BHARAT HEAVY ELECTRICALS LIMITED
PROJECT ENGINEERING MANAGEMENT, NOIDA

CORRIGENDUM- 04

PROJECT	:	1x800 MW NTPC SIPAT STP PROJECT, STAGE-III (EPC)
PACKAGE	:	COOLING TOWER - Induced Draft Cooling Towers (IDCT)
ENQUIRY NO	:	77/23/6186/AMI Date 11.12.2024
SUBJECT	:	Tender due date extension & replies to pre-bid queries

Vendor Drg. No. : PE-DG-520-603-C005
Orgn. Drg. No. : 8003-001-301-POC-C-111
Revision No. : 00
Drg. Title : PLANT DRAIN LAYOUT
App. Category : CAT-II
Release Date : 19/11/2024

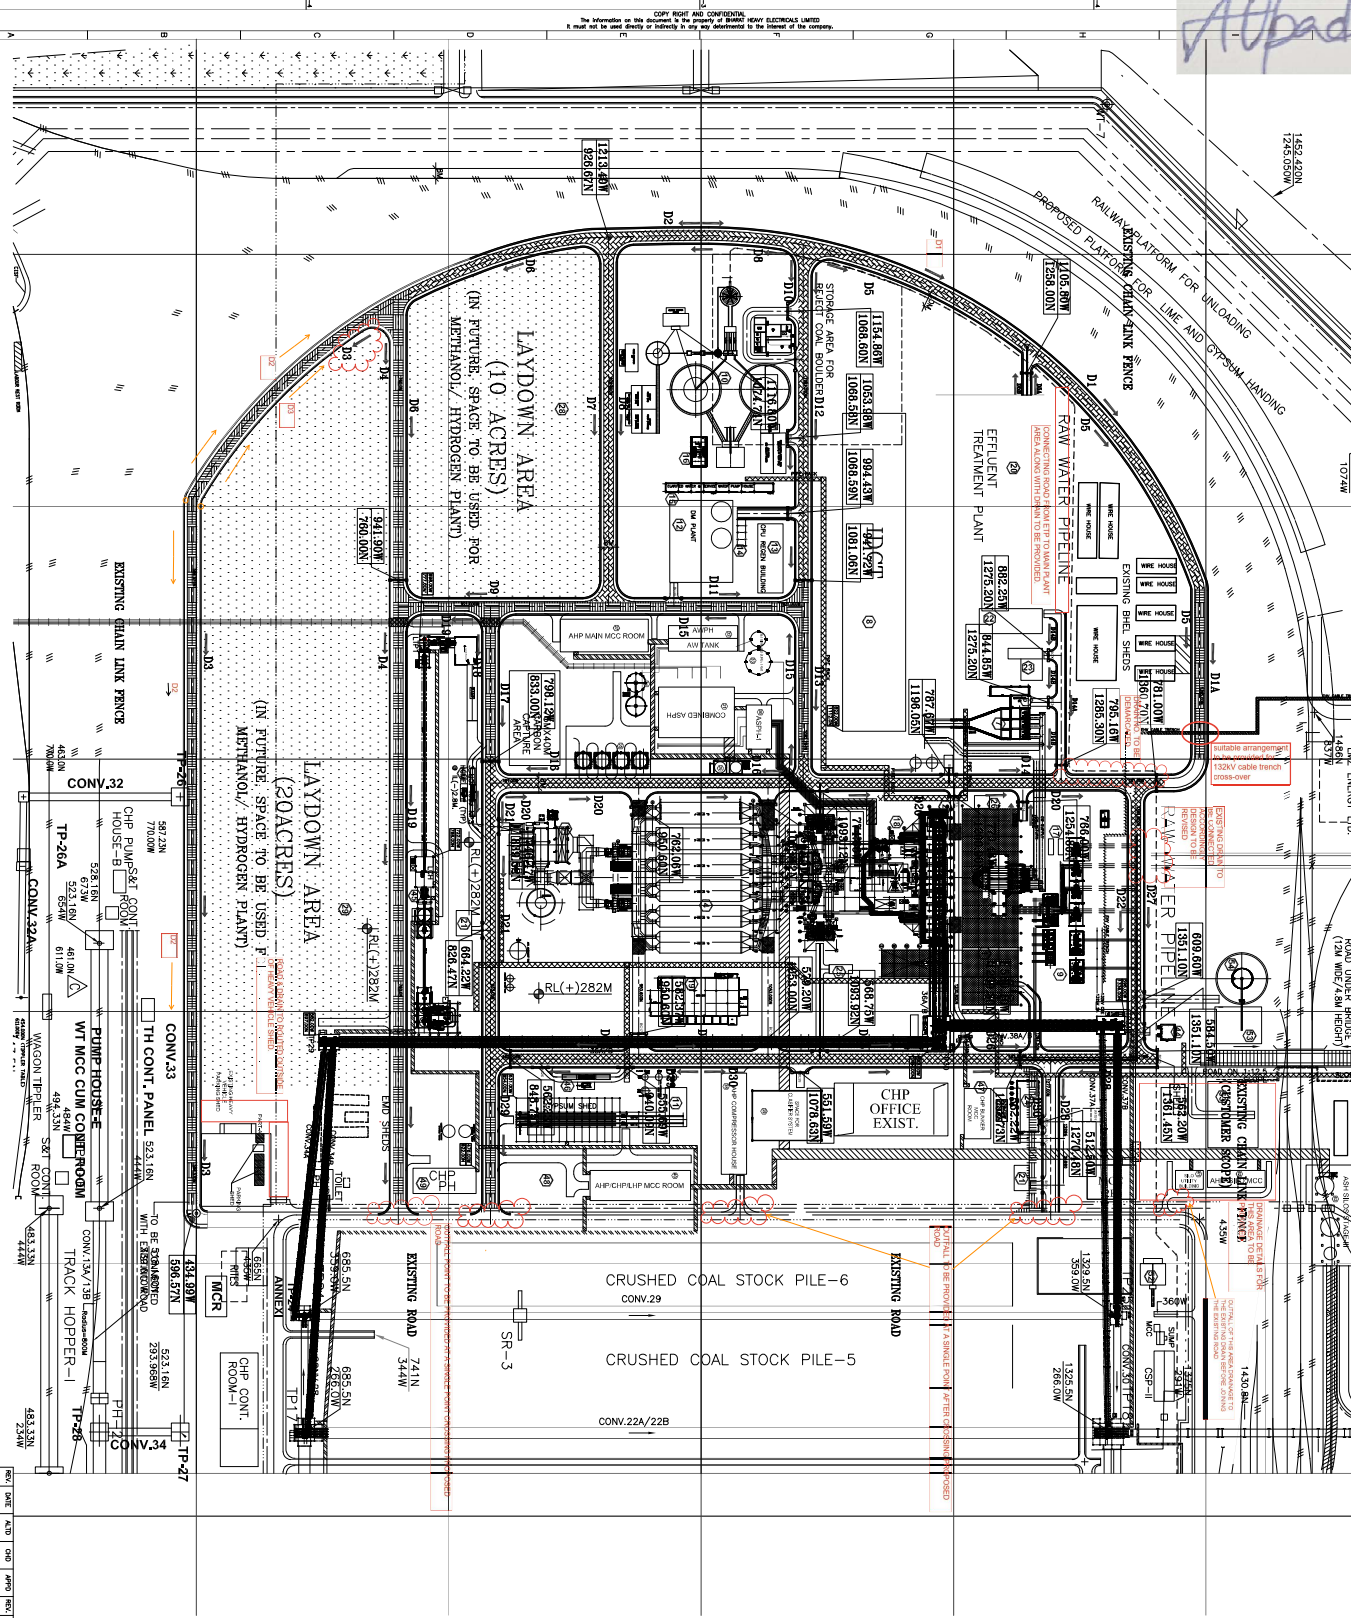
Comments : 1. COMMENTS ON DESIGN OF DRAIN, PLOT PLAN & LAYOUT OF ROAD MAY PLEASE BE INCORPORATED.
2. CONNECTION DETAILS OF PROPOSED DRAIN TO EXISTING DRAIN TO BE PROVIDED.
3. DRAINAGE ARRANGEMENT FOR LAYDOWN AREA NEAR SWITCHYARD TO BE PROVIDED.
4. Culvert to be mandatorily provided at crossings wherever vehicular /material movement is envisaged.
5. STARTING & END POINT OF EACH DRAIN TO BE DEMARCATED ON DRAWING.
6. CULVERT FOR CROSSING THE ROAD BY DRAIN TO BE DEMARCATED.
7. DESIGN OF D1A, D14A & D14B TO BE PROVIDED.
8. DRAIN NO. D18A, D12B & D30A ARE NOT MARKED IN DRAIN LAYOUT & REQUESTED TO REVIEW THE SAME.
9. ANY CABLE CROSSINGS THROUGH DRAIN ARE TO BE DEMARCATED.
10. COMMENTS AS MARKED.

DRG Title: PLOT PLAN (GLP)

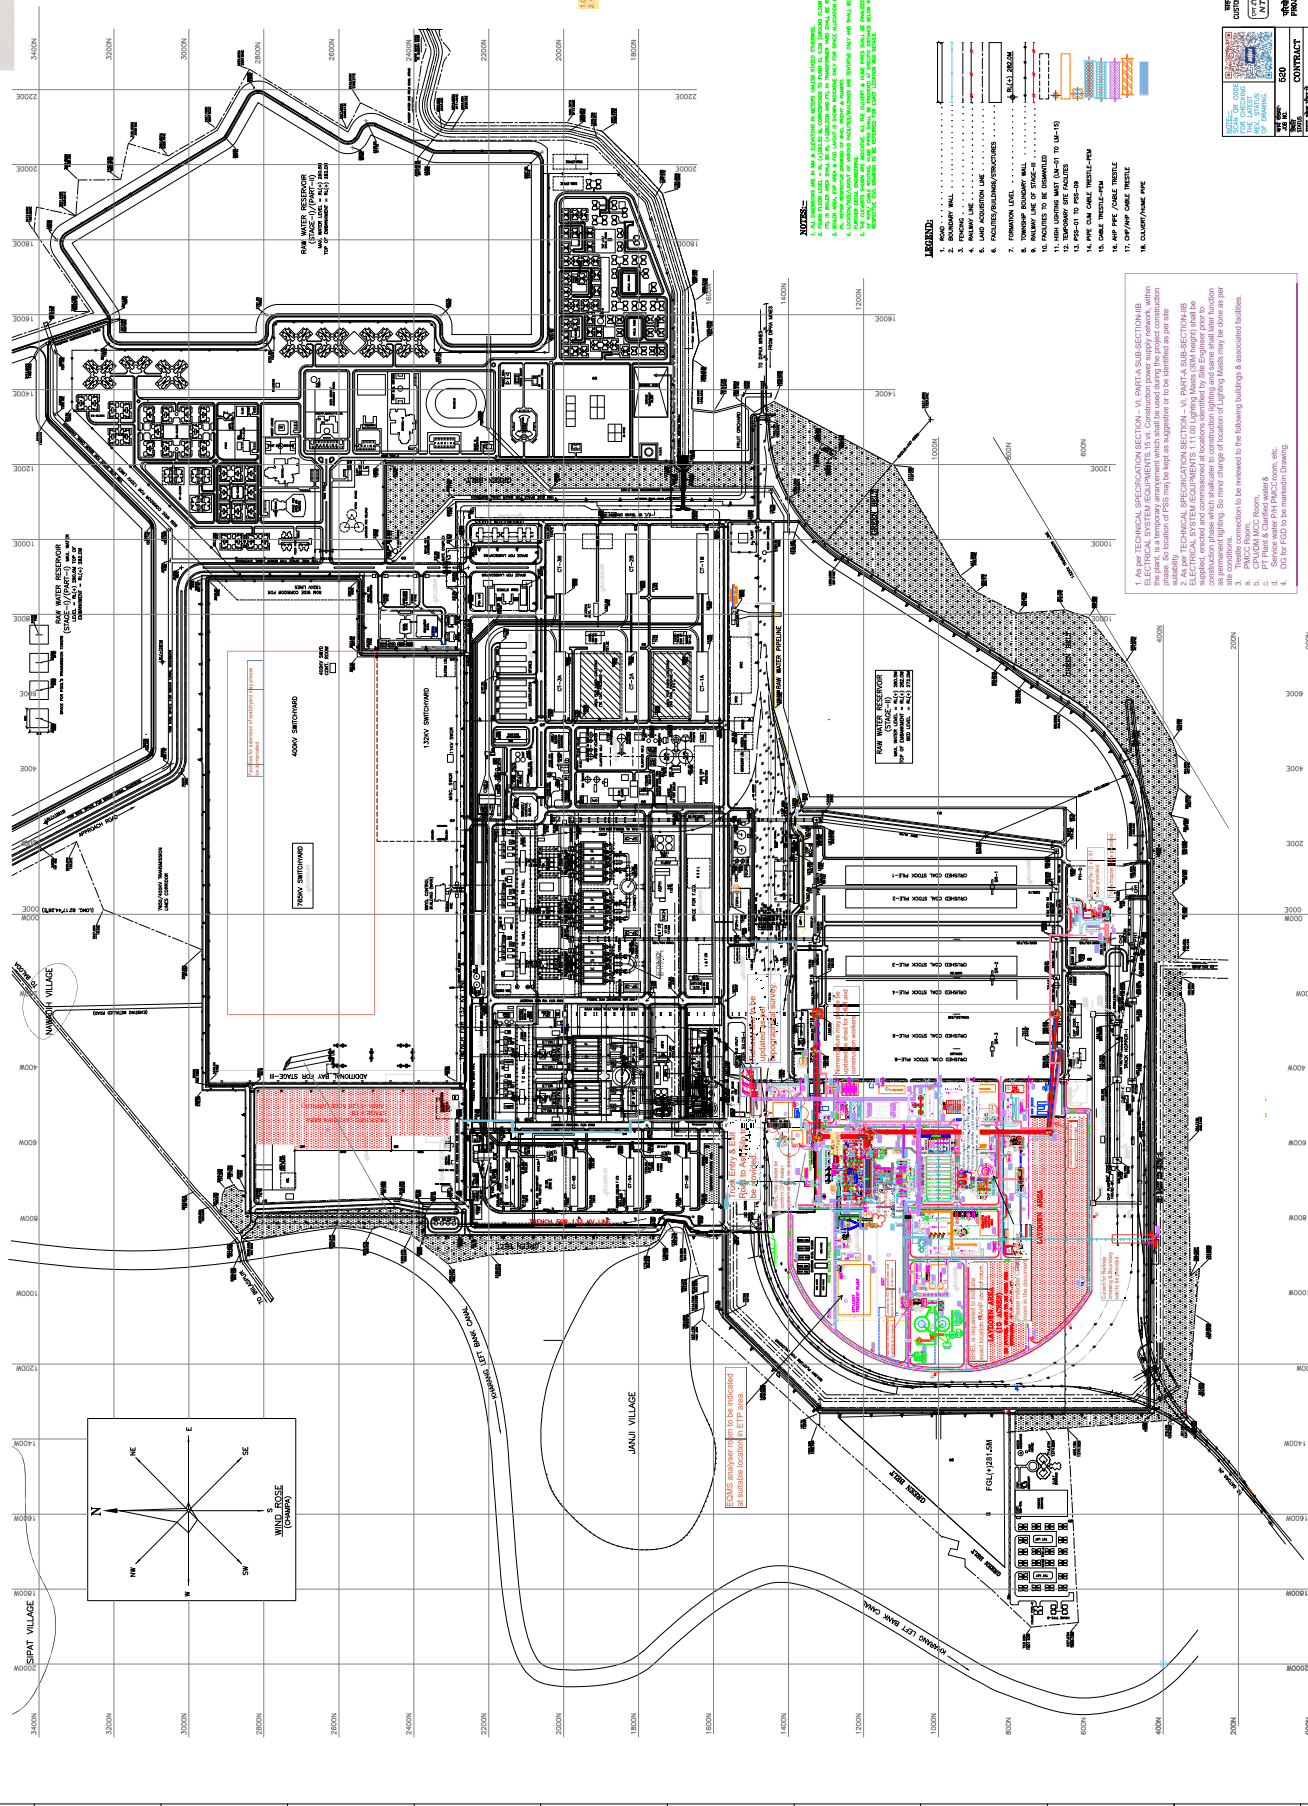
Comments : 1) Comments are marked on the drawing.
2) Based on the pointwise replies given by BHEL, we have no major comments. However, BHEL to note/confirm the following:

i. In case of any contradiction in the Plot Plan and the stipulations of Technical Specifications (w.r.t. Quantities/Specification of Equipments/Systems), the stipulations as mentioned in Technical Specification shall prevail and any changes required in layouts to meet the system design/specification requirement, same shall be taken care in the plot plan by BHEL.
ii. Dimensions of equipments are tentative and shall be updated based on final layout drawings of respective buildings/equipments.
iii. NTPC safety policy and various safety requirement has already been indicated in the site regulation and safety section of GCC. This document shall be read in conjunction with site regulation and safety section of GCC. In case of any contradiction, the stringent of the two requirements (in the opinion of NTPC) shall prevail. iv. Approval of this document does not relieve M/s BHEL from any of its obligations, duties or responsibilities under the Contract.

Sl. No	NTPC Comments dtd: 13.11.2024	BHEL reply dtd: 20.12.2024
1.	Location of O&M and construction workers to be indicated	This is worker's rest room (06 Nos) as per specs and has been shown in plot plan.

2.	Various facilities of DM plant to be shown	The tentative space (not to exceed) for DM plant has been shown. The facilities of DM plant shall be updated upon finalization of internal layout.

3.	Road along clarified water & service water PH to be indicated.	The same has already been shown in plot plan.
4.	Area to be demarcated for CST Tank & PH	Noted.

5.	STP to be marked as per Technical specifications.	3 Nos STPs are shown inline with technical specification requirement.
6.	Rain water Harvesting scheme to be shown in plot plan	As per specification it is ground water recharge which seems not feasible. The engineering of scheme of rain water harvesting is in progress and shall be submitted in next revision.

7.	Facilities for ETP to be marked on Plot plan	The tentative space (not to exceed) for ETP has been shown. The facilities of ETP shall be updated upon finalization of internal layout.

8.	Approach road to ETP & IDCT to be shown	Noted and shown in plot plan.
9.	Laydown area near Switchyard to be shown	Already shown in plot plan.
10.	Ash slurry pipe line to be shifted by about 10m towards TP-26 as area was already allocated for existing ST-I & II.	Refer modified ash slurry pipe route.
